Accessibility Survey

City of Downey Barlin Avenue - Cheyenne Street To Gardendale Street

Date of Inspection
4/10/2017

Disability Access Consultants

Change In Level South Of Cheyenne Street @ 33.912109999121, -118.145195692778

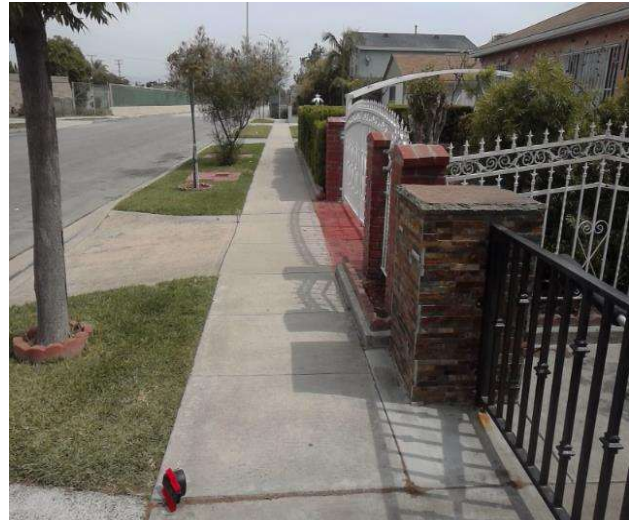
There is a change in elevation greater than recommended value.

On-Site Finding 0.62 inches

Ensure that the change in elevation is within the recommended value.

Recommendation Up to 0.25 inches

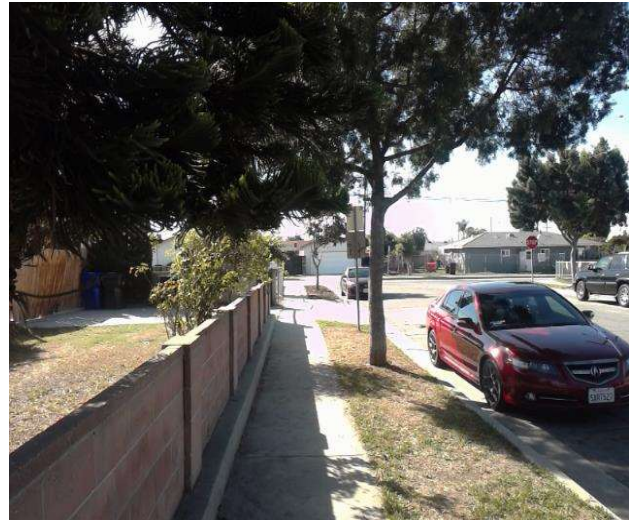
Overhead obstruction height is not compliant.

On-Site Finding 70.00 inches

Provide a compliant vertical clearance height.
